# intel® Technical Advisory

TA-0680-1

## Intel® Server Board S875WP1-E: Two Capacitors May Prevent Installation of Boxed Intel® Processor Fan Heatsink.

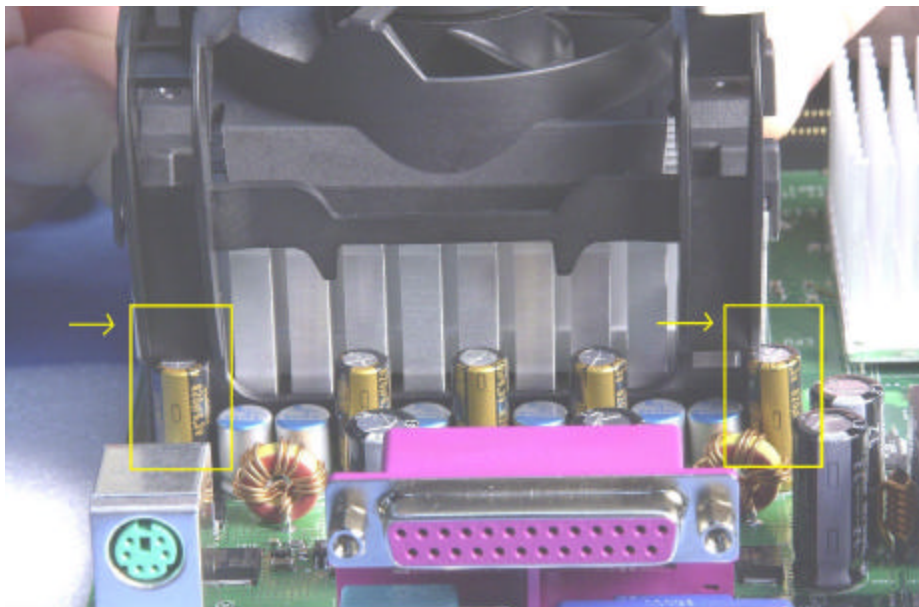
Intel® Server Board S875WP1-E, AA# CXXXXX-304, were built with two capacitors at locations C1C4 and C3C1 near the processor retention mechanism. These locations should not have been populated with capacitors. The height of the capacitors at locations C1C4 and C3C1 may prevent the fan heatsinks included with Intel boxed processors supported by server board S875WP1-E from being installed (see photo below).

Capacitors were utilized at locations C1C4 and C3C1 for builds of server board S875WP1-E with AA# CXXXXX-304 due to a Bill of Material (BOM) markup error.

An ECO has been released which removes the capacitors from locations C1C4 and C3C1. This ECO will result in server board S875WP1-E PBA to be changed to AA# CXXXXX-305. This ECO was implemented on 12/2/03
